AMENDMENT NO. 0001 TO ADVERTISED RFP DACW31-03-R-0008
EFFECTIVE: APRIL 23, 2003

LUKE C. MOORE ACADEMY HIGH SCHOOL

SHEET NO: S-4.2

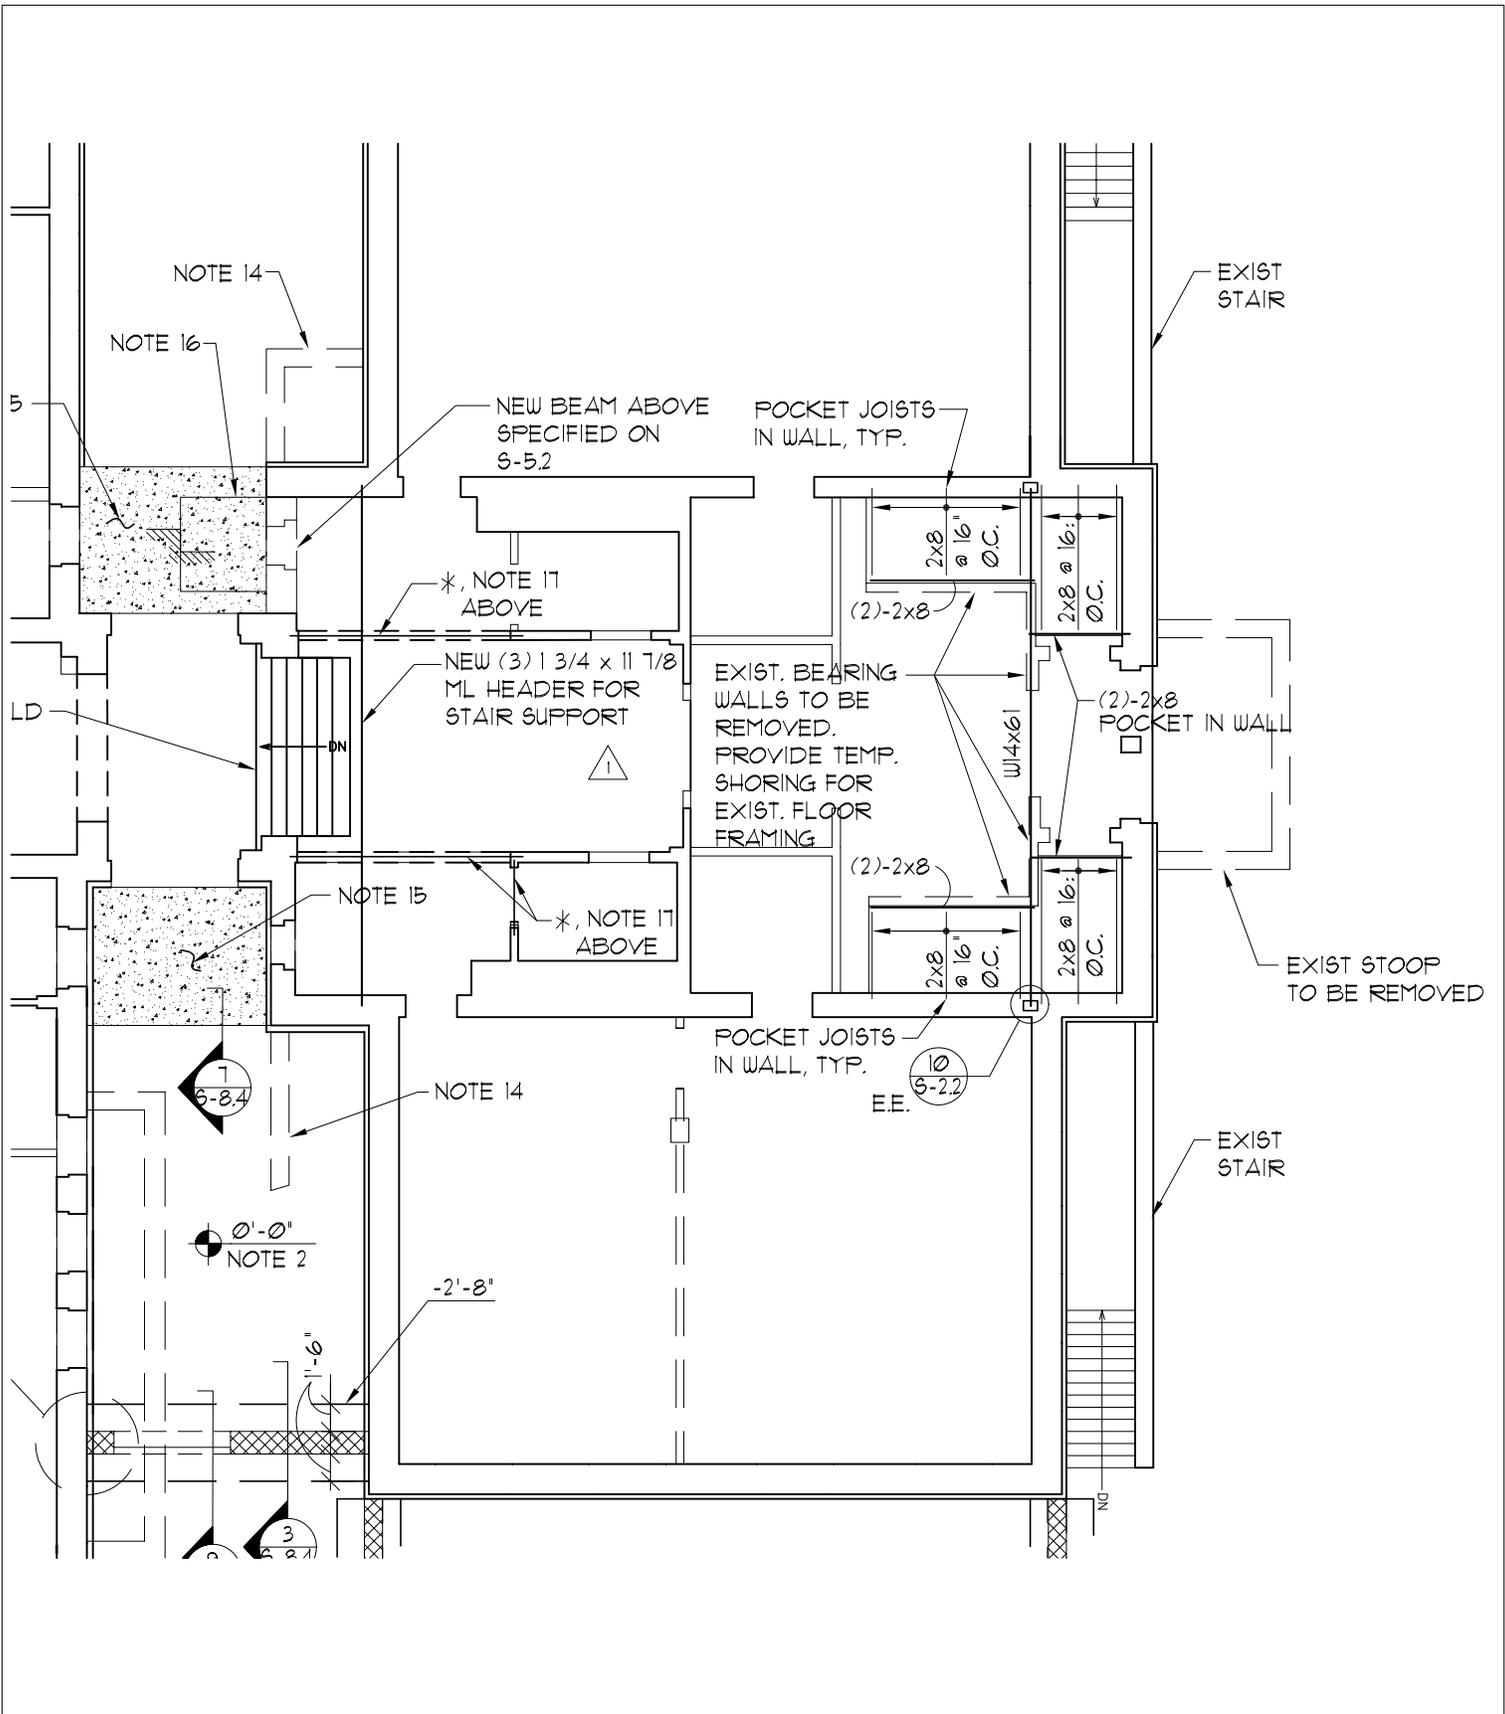
- 86) Sheet S-4.2:
a) At two areaways, revise note to read “Optional bid item”.
b) Revise per attached sketch SK-S-5, dated 04/17/03.
c) Revise elevation of exterior wall footing at Stair 04 from -2’-8” to extend down to align with elevation of lowest footing of adjacent existing building wall footing.
